Project: COMPTON COMMUNITY COLLEGE DISTRICT- FOOTBALL FIELD

ADDENDUM NO. 1

Date: June 17, 2015

Compton CCD
Football Field
RFC #4
Pro Gold Area

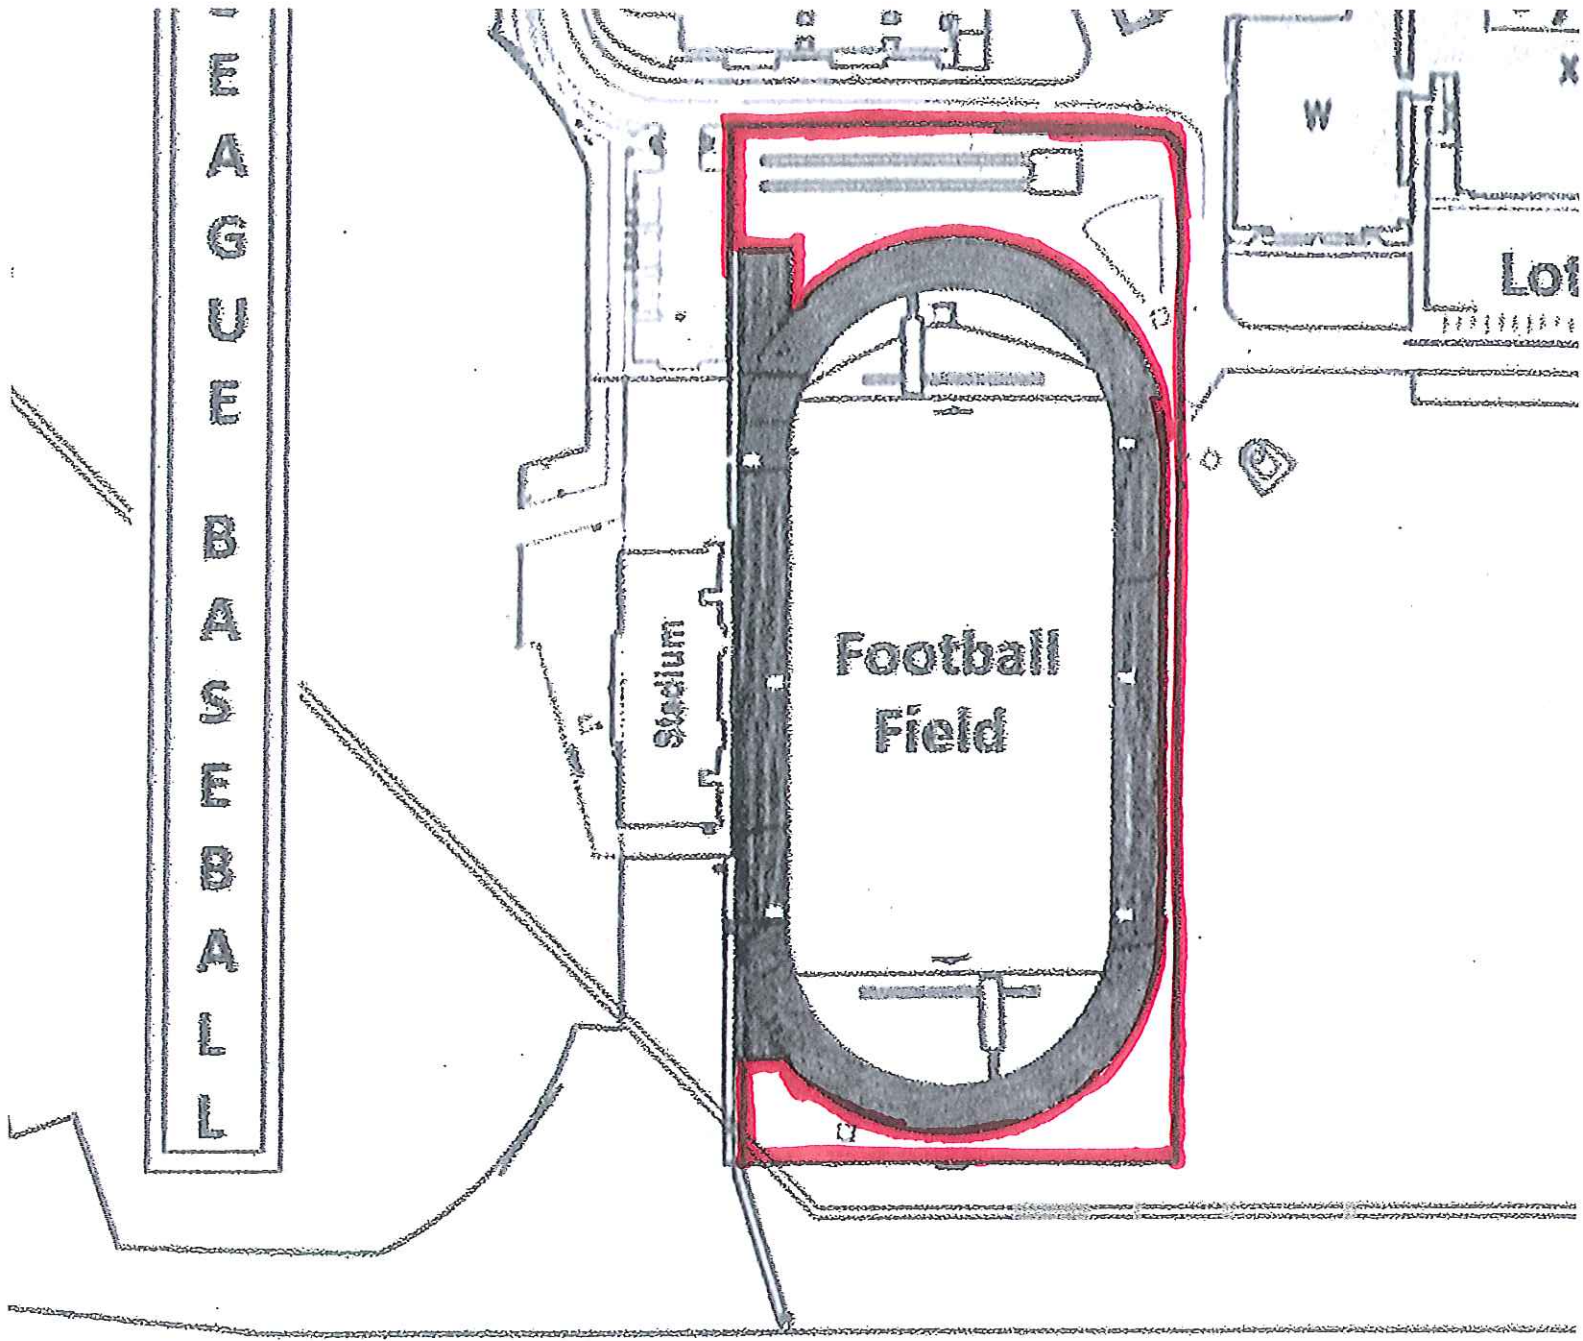
It was discussed at the job walk that the Contractor was to blade off areas around the track to a depth of 3" first spraying weed kill, applying rodent abatement measures, and removing weeds, then installing Pro Gold. No plan has been included to determine the quantity of Pro Gold require. Will Pro Gold be required? If so, Please furnish plan and provide spec on rodent abatement and length of maintainance.

- Response: 1. See attached site plan showing location outlined in red.
2. Provide per specification section 01 01 00 Scope of Work 1.2.A.1.J.
3. Existing contours to remain in place
4. See Addendum No. 1 Item 1.4 for rodent abatement requirements.
5. There is no maintenance required by this contractor.
